Date: January 28, 2015
To: Prospective Bidders
Subject: Addendum No. 1
Traffic Signals Improvement/ Repairs Project
City of Galveston, Texas
Bid #15-28

EXHIBIT A

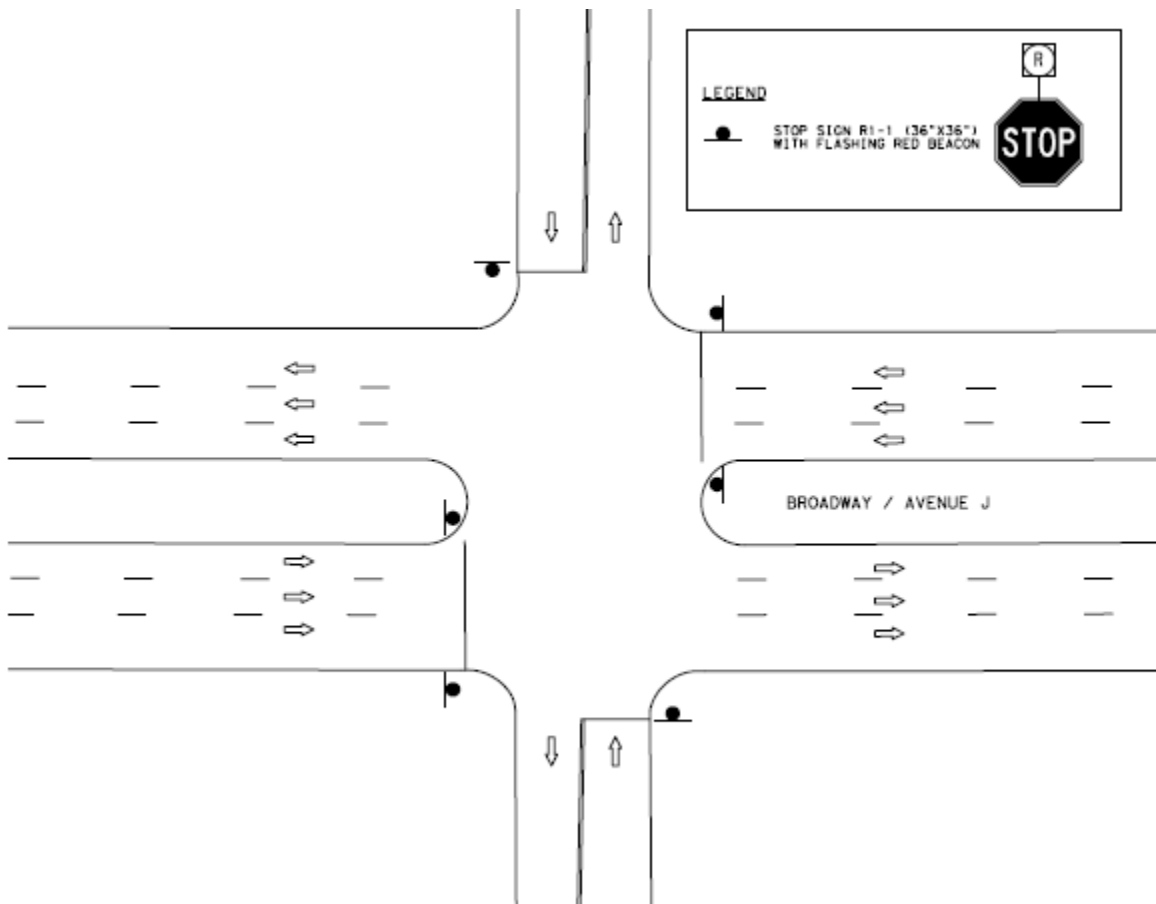
1. Maximum duration of down time for a traffic signal repair location is limited to 72 hours, during which time it shall operate as a stop controlled intersection. A recommended traffic control plan for such operation at a repair intersection shall be as shown in attached Exhibit A.
